April 14, 2010

During the second comment period for the proposed 2011 ENERGY STAR New Homes guidelines, EPA received over 140 pages of comments from respondents. EPA has reviewed all comments and has greatly refined the guidelines in response. This document provides a summary of the most significant changes, but omits many smaller changes that were made, such as minor clarifications and the addition of formal definitions. For more information, please see the revised guideline documents and EPA's detailed response document, which contains all policy changes made and the accompanying rationale.

**Exhibit 1: ENERGY STAR New Homes Version 3.0 Implementation Schedule**

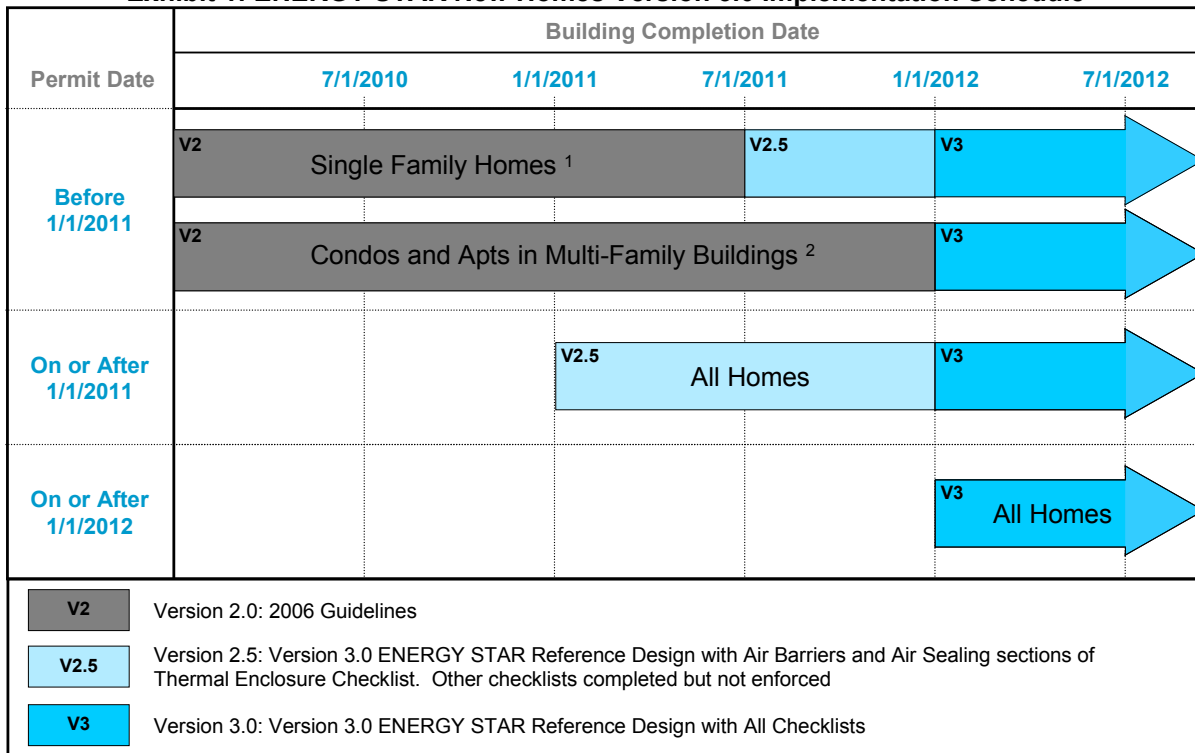
EPA has modified the implementation timeline by allowing additional time for multi-family buildings to transition to the version 3.0 requirements. Furthermore, it has clarified that some homes may use a transitional version of the guidelines during the 2011 calendar year, named v2.5, which is composed of the version 3.0 ENERGY STAR Reference Design coupled with the Air Barriers and Air Sealing sections of Thermal Enclosure Checklist. Under this version 2.5, the other inspection checklists shall be completed but not enforced. The revised implementation timeline is illustrated in Exhibit 1.
